We have received another neighbour notification regarding the amended **Planning Application 18/00220/F**.

Re – Planning Application 18/00220/F – Comments from Ball Colegrave Ltd

Fig 1

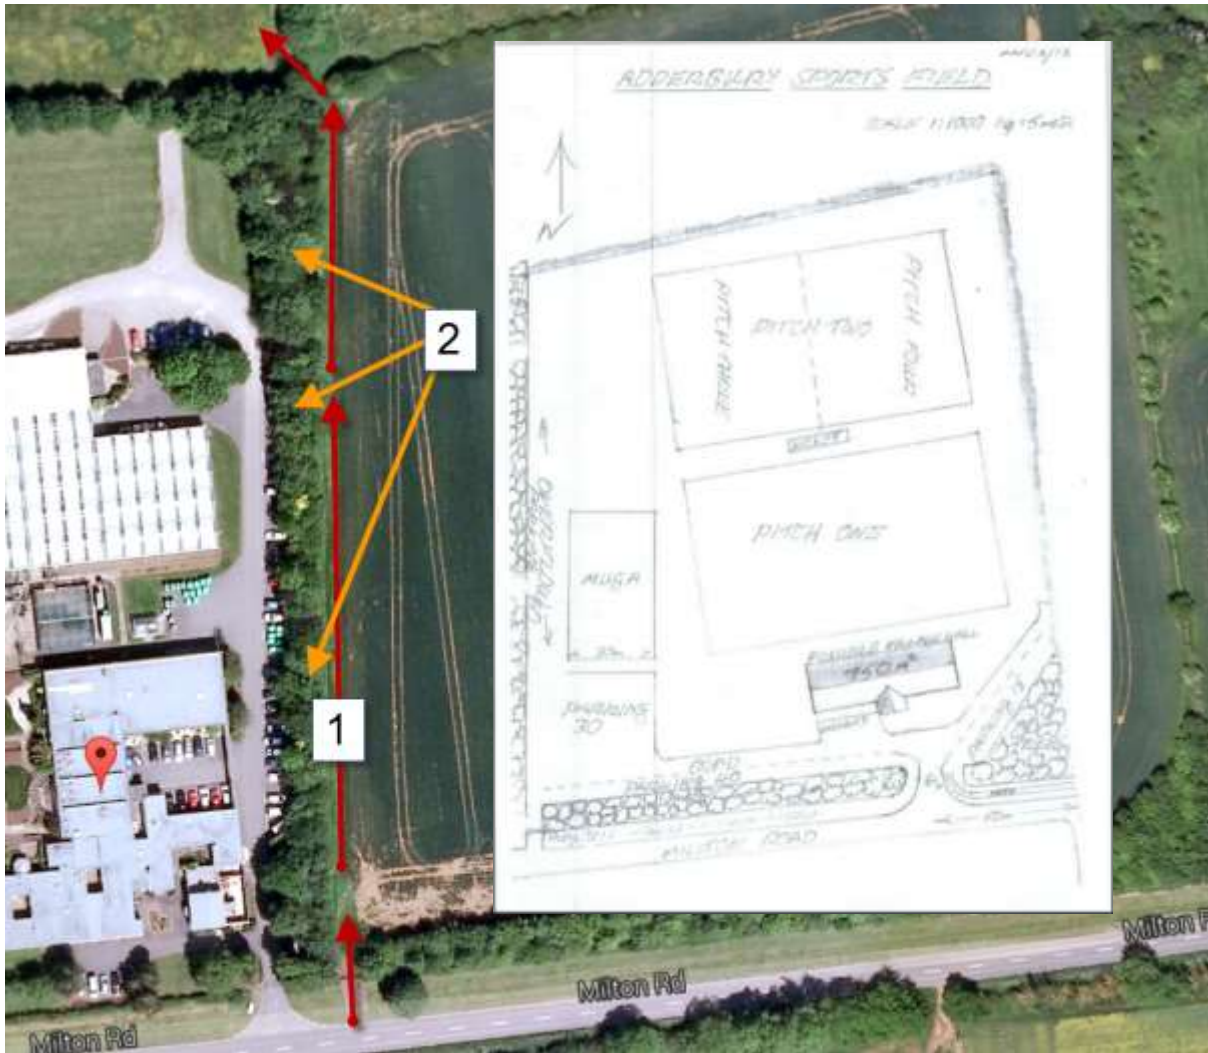
1. Access for machinery and vehicles adjacent to the Ball Colegrave boundary to the gate at the bottom of the field, please see Fig 1 - **No 1** on the picture below,

3. That the existing coppice hedgerow be kept and maintained, this was planted by the Colegrave family to act as a windbreak for the Ball Colegrave trial grounds and offices, see Fig 1 - **No 2** on the picture above.

Fig 2

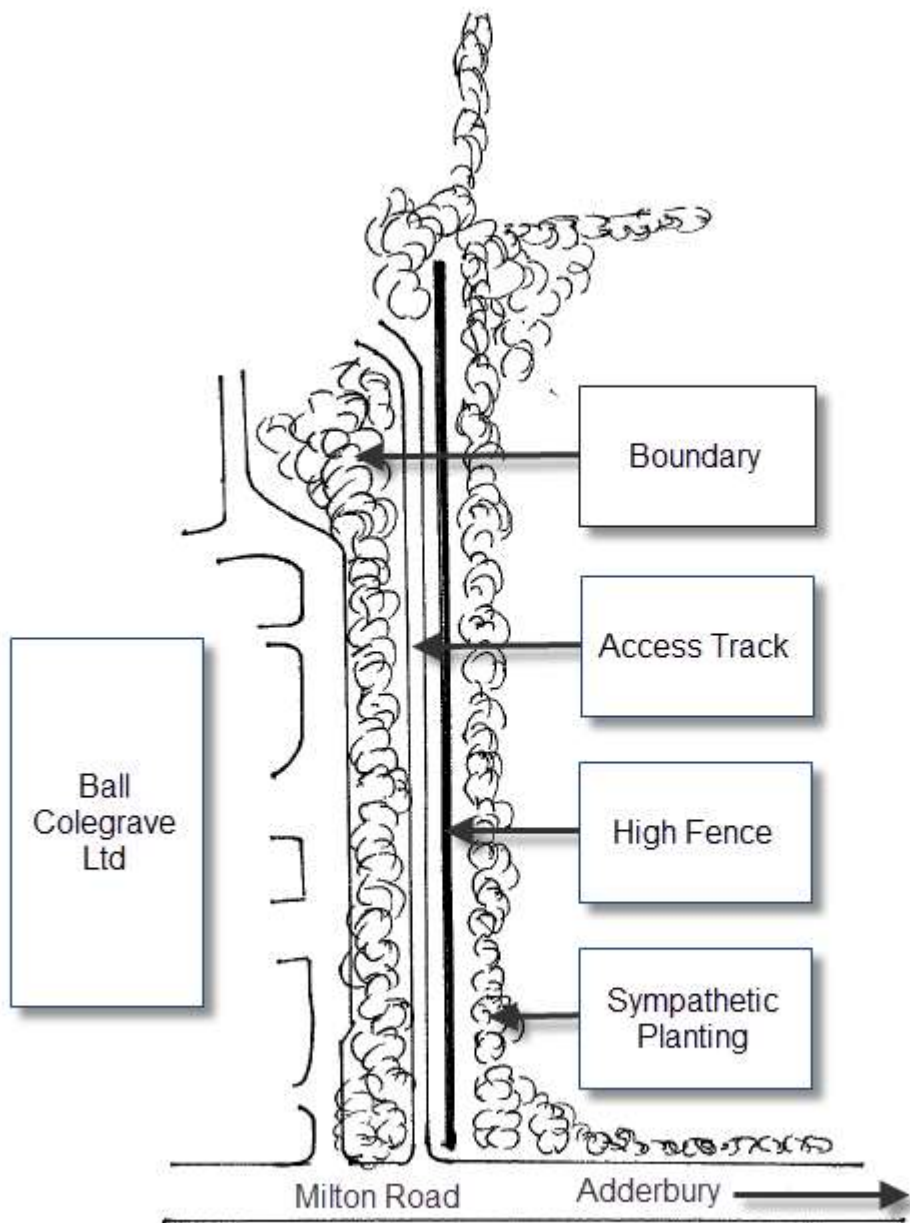
2. That a secure high fencing along to the east of the access track be erected (see Fig 2), this should be suitable to protect our greenhouses and cars parked along the hedge line (our main car park). These greenhouses are critical to our operations here in West Addersbury.

4. Beyond (East of) the fence a sympathetic planting of indigenous species to screen the fence and blend into the surrounding country side. (Please see Fig 2).
